BYTEK VW Expansion Project
1325 St. Laurent Blvd.
Ottawa, Ontario
Our Ref: 2301

Addendum N° 7

Date: January 7th, 2025

Addendum #2

GROUND FLOOR FINISHES PLAN

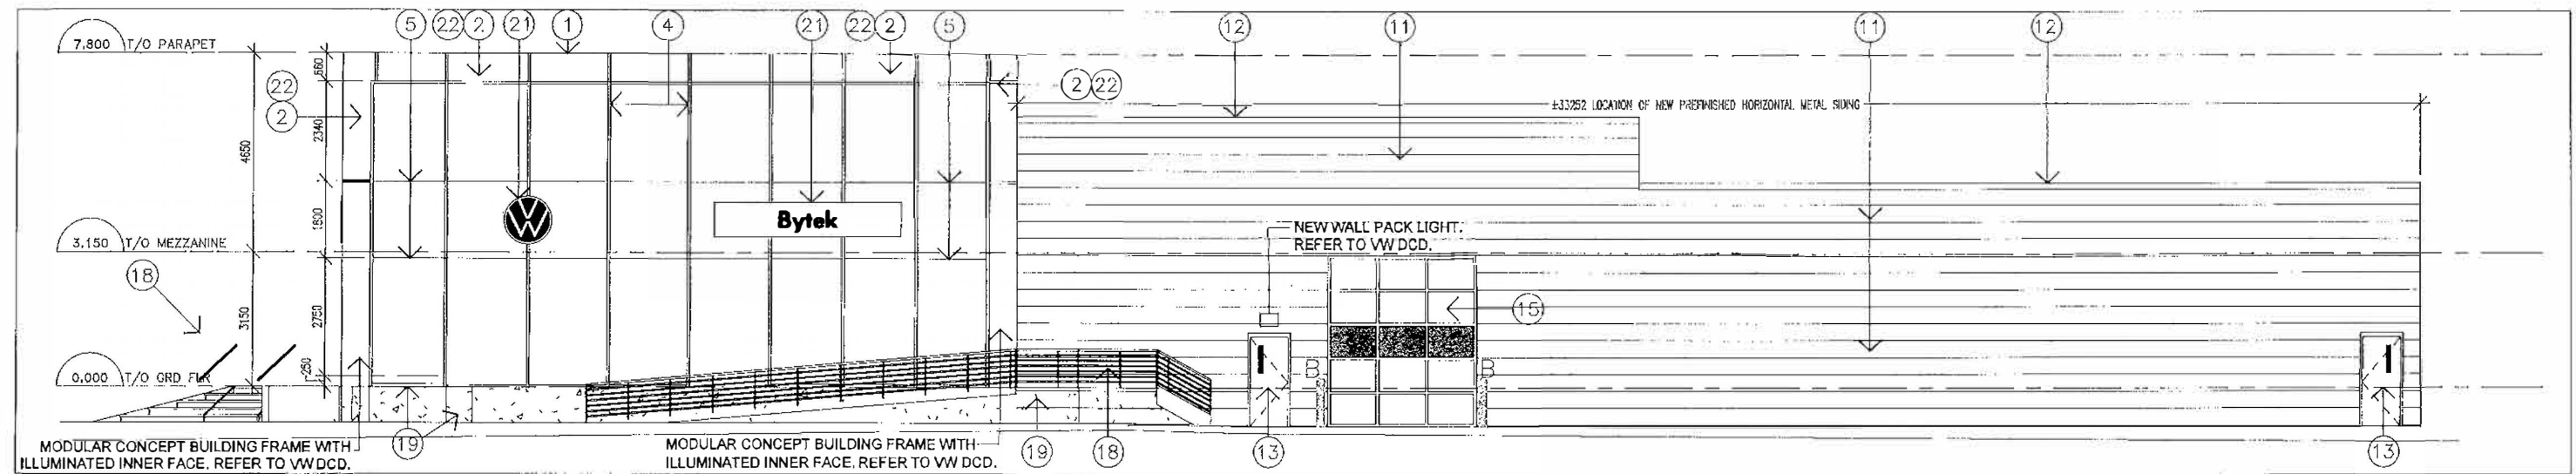
- 1.5 Reference drawings A-505, Mezzanine and Basement Floor Finishes Plans and A-506 Ground Floor Finish Plan, Revised
 - 1.5.1 Refer to VW DCD.
- 1.6 Siding clarification

EXTERIOR ELEVATIONS - EXTENT OF NEW METAL SIDING FOR SEPARATE PRICING OPTION

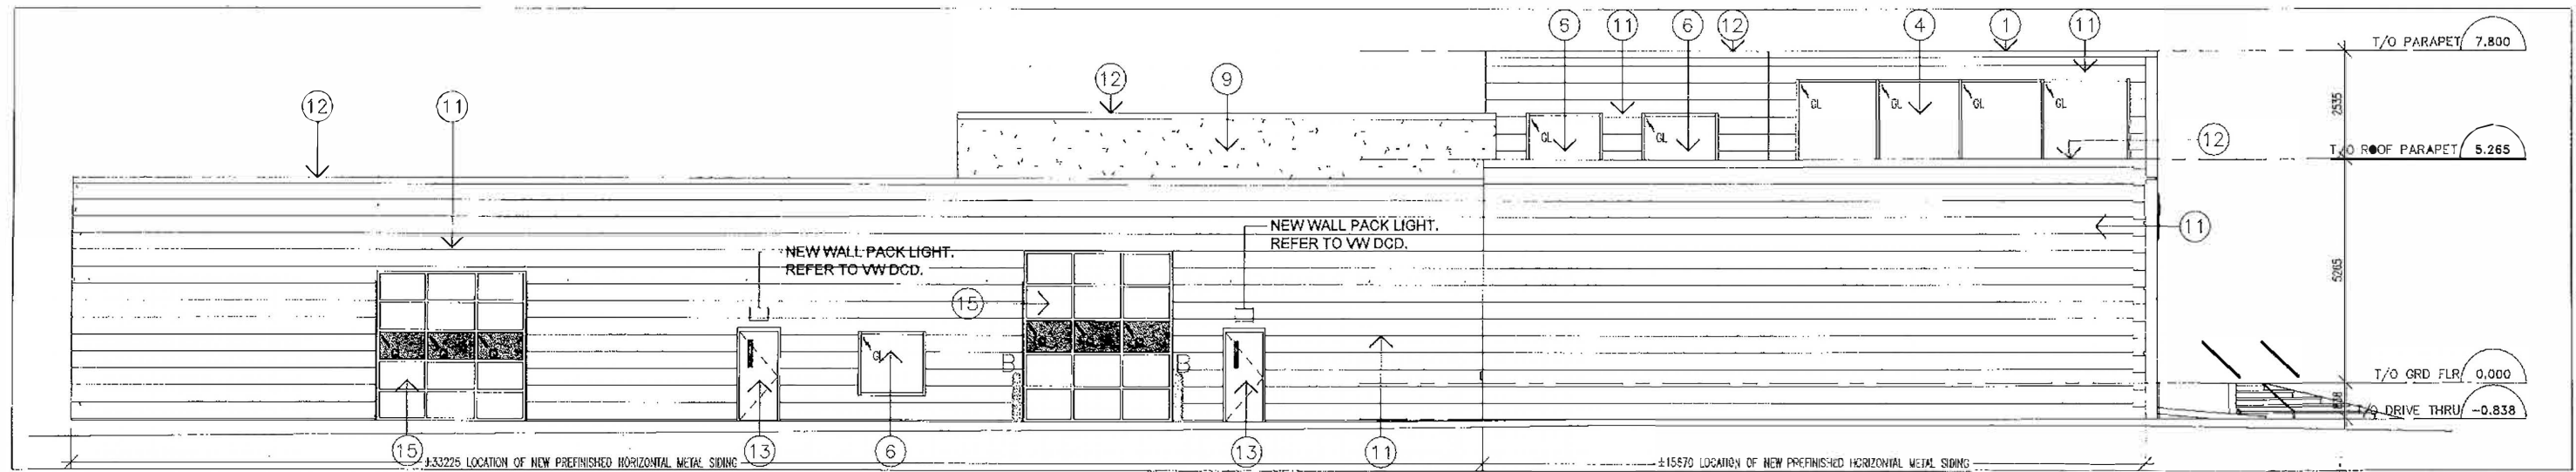
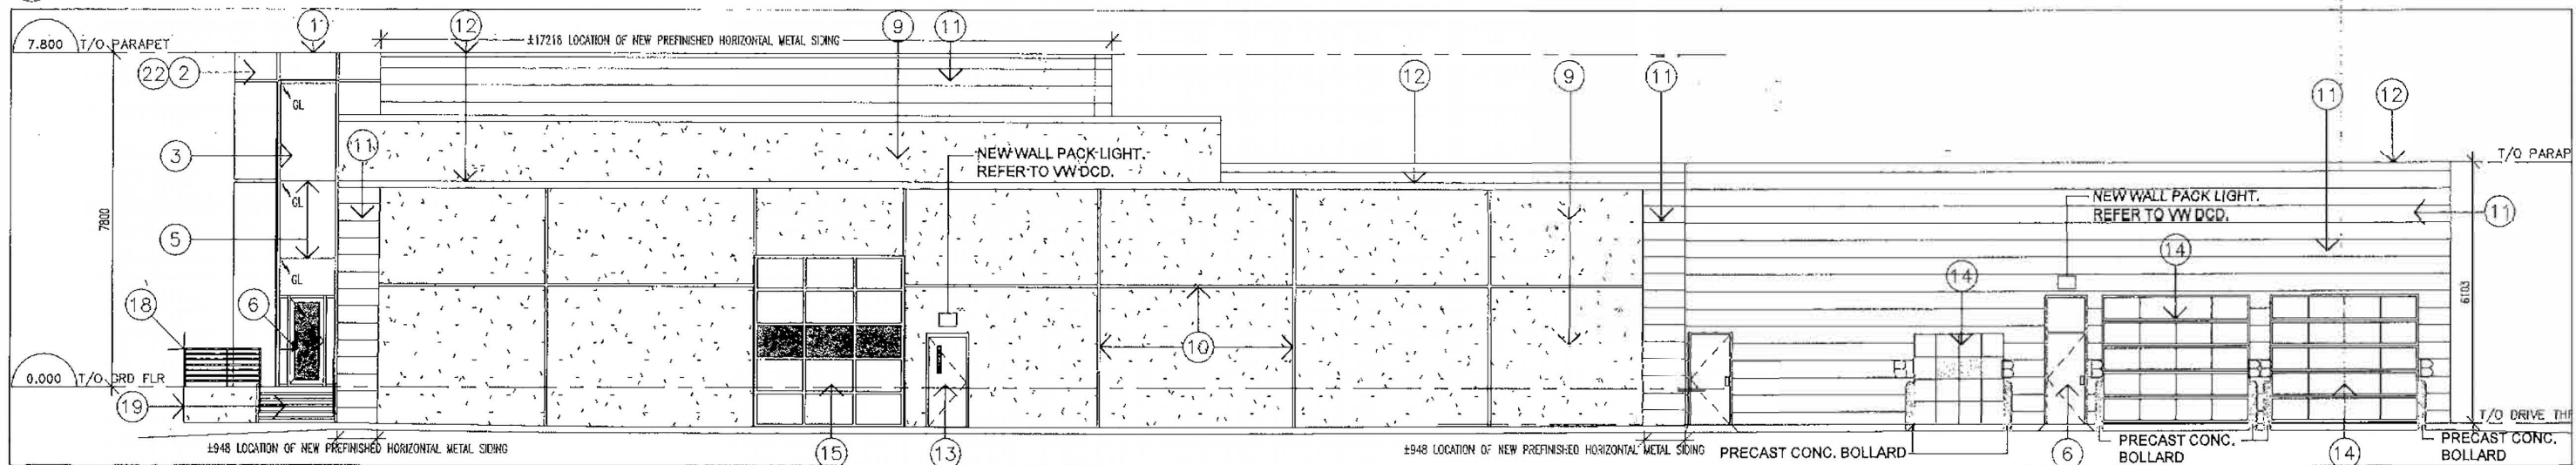
- 1.6.1 Provide separate identified pricing for installation of prefinished horizontal metal siding on East and West elevation in lieu of patching and repainting EIFS.

project BYTEK VW - RENOVATION
1325 ST. LAURENT BLVD.
drawing
PARTIAL BASEMENT PLAN - FINISHES PLAN

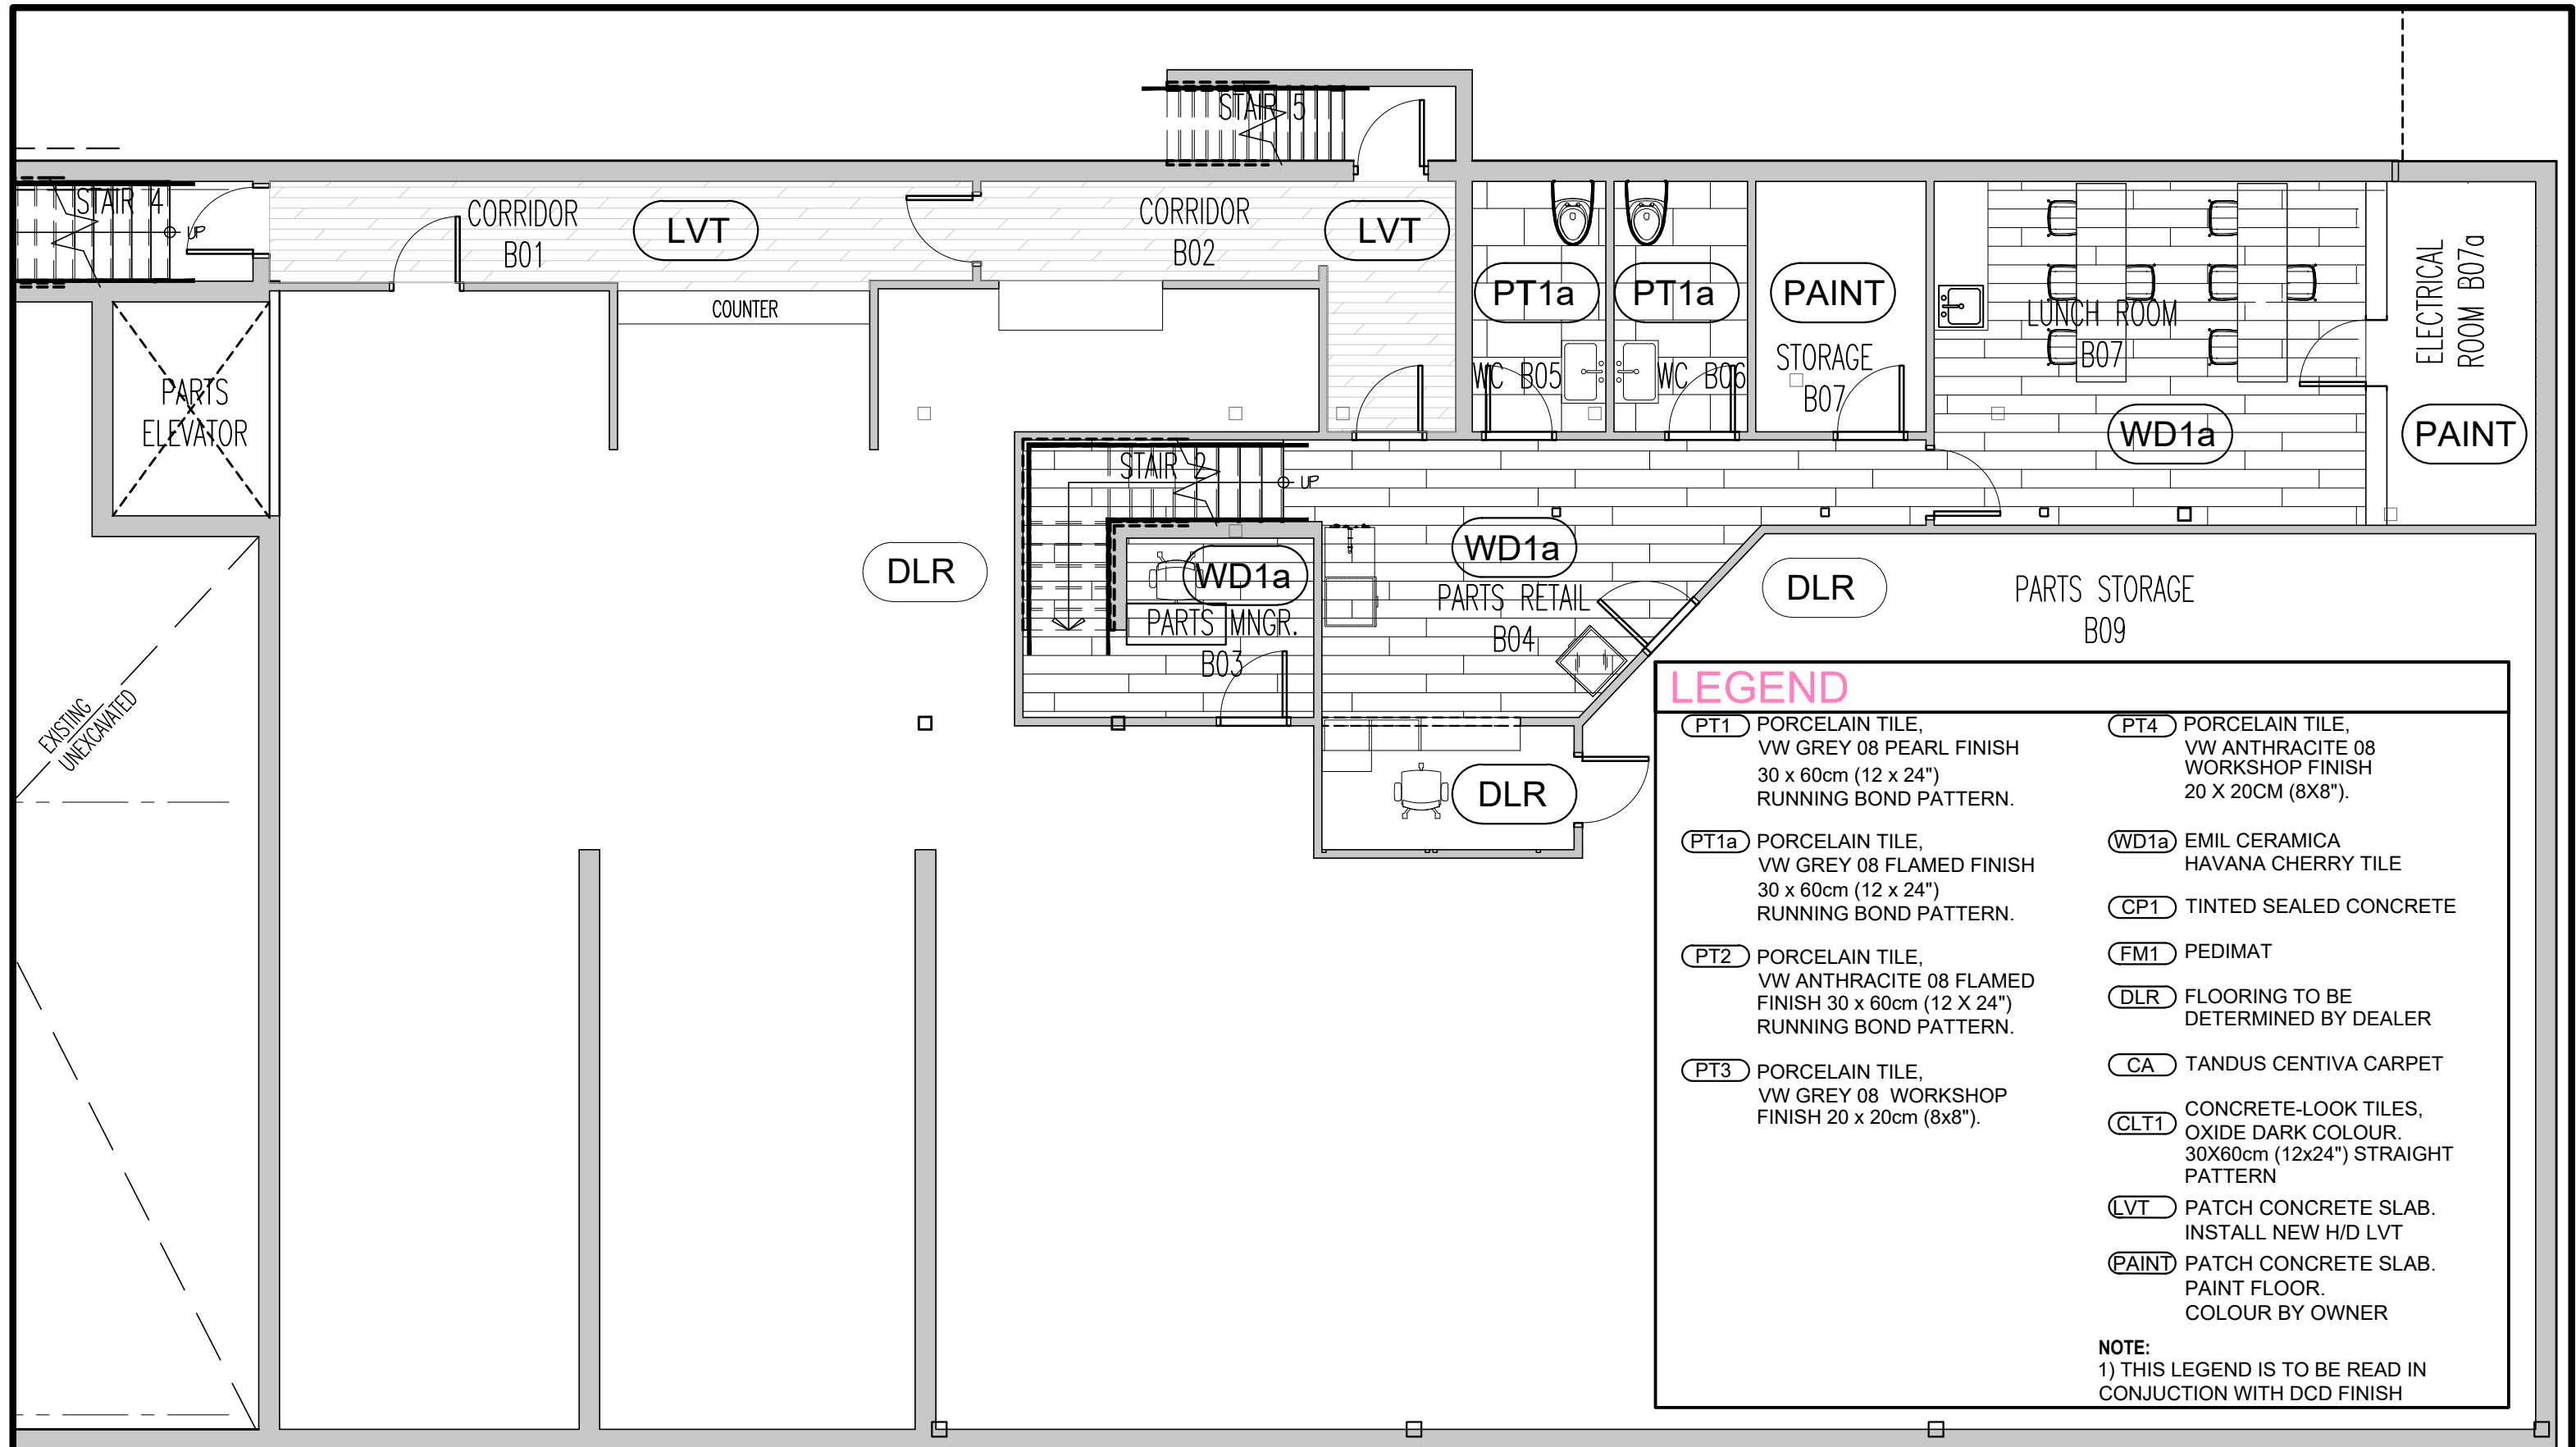
- 1.8 Finishes revision
 - 1.8.1 Provide revised basement floor finishes as indicated on ASK-3
- 1.9 Floor Repair clarification
 - 1.9.1 Provide separate price for all concrete slab replacement / repair as required to reinstate basement and shop floors associated with additional plumbing work.

- 1.10.1 Supply and install 50 sq.m. of Expona Simplay to existing and reinstated basement floor slab.
